STAFF REPORT
COMMUNITY DEVELOPMENT DEPARTMENT

SUBJECT: Prescott Ridge Subdivision No. 5
[FP-2024-0019](#)

Final Plat consisting of 46 building lots and three (3) common lots on 4.68-acres of land in the R-15 zoning district, by KM Engineering, LLP.

B. Final Plat (dated: 08/23/24)

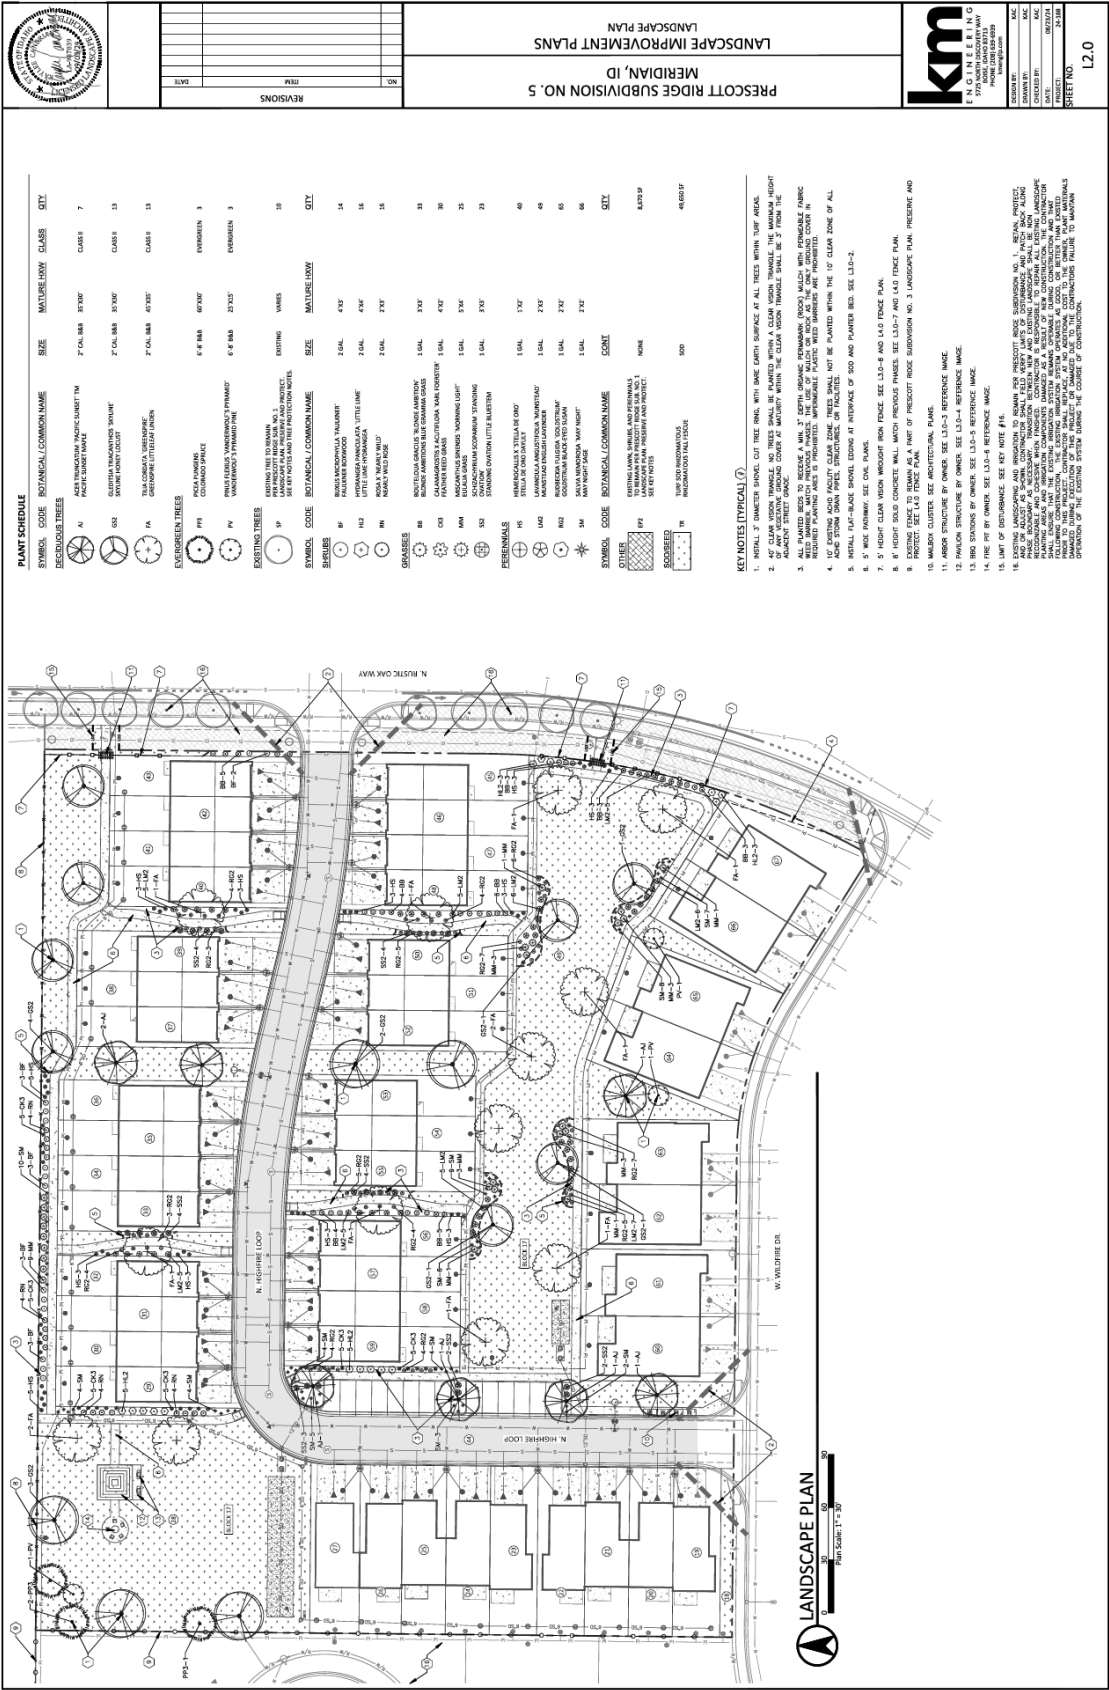
3. Prior to submittal for the City Engineer's signature, have the Certificate of Owners and the accompanying acknowledgement signed and notarized.
4. The final plat shown in Section V.B prepared by KM Engineering, stamped on 08/23/2024 by Aaron L. Ballard, shall be revised prior to submittal of the final plat for City Engineer signature, as follows:

- a. Under References, #R5 – include the Book and Page numbers of Prescott Ridge Subdivision No. 3.
 - b. Depict zero (0) setbacks on lot lines where attached units are proposed where a building setback won't be required/provided.

8 5' HEIGHT CLEAR VISION WROUGHT IRON FENCE REFERENCE IMAGE

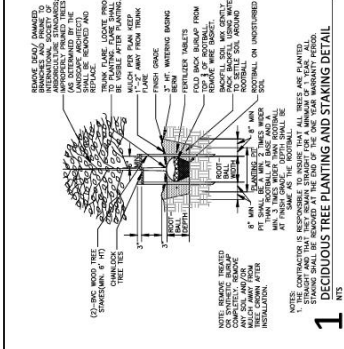
5. The landscape plan shown in Section V.C, dated 07/12/24, shall be revised as follows:
 - a. The wall along the northern boundary of the property is required to be constructed with development of the medical campus/hospital on the abutting property to the north and shall be a CMU wall with texture and a color complimentary to the subject residential structures per requirement of the Development Agreement (DA) – plain CMU block is not allowed. If the developer of the subject property constructs the wall instead, it shall comply with this requirement. Either remove the wall from the plans or revise the detail to reflect compliance with the associated DA provision.

- b. Depict fencing along all common open space lots to distinguish common from private areas as set forth in UDC 11-3A-7 (see standards for specific fencing type). Extend clear vision fence at the rear of the street buffer along N. Rustick Oak Way.

- c. The wall along the northern boundary of the property is required to be constructed with development of the medical campus/hospital on the abutting property to the north and shall be a CMU wall with texture and a color complimentary to the subject residential structures per requirement of the Development Agreement (DA) – plain CMU block is not allowed. If the developer of the subject property constructs the wall instead, it shall comply with this requirement. Either remove the wall from the plans or revise the Detail #7 on Sheet L3.0 to reflect compliance with the associated DA provision. *Note: A temporary fence may be erected and removed upon construction of the CMU wall; however, double fencing is prohibited per UDC 11-3A-7A.7b(4).*
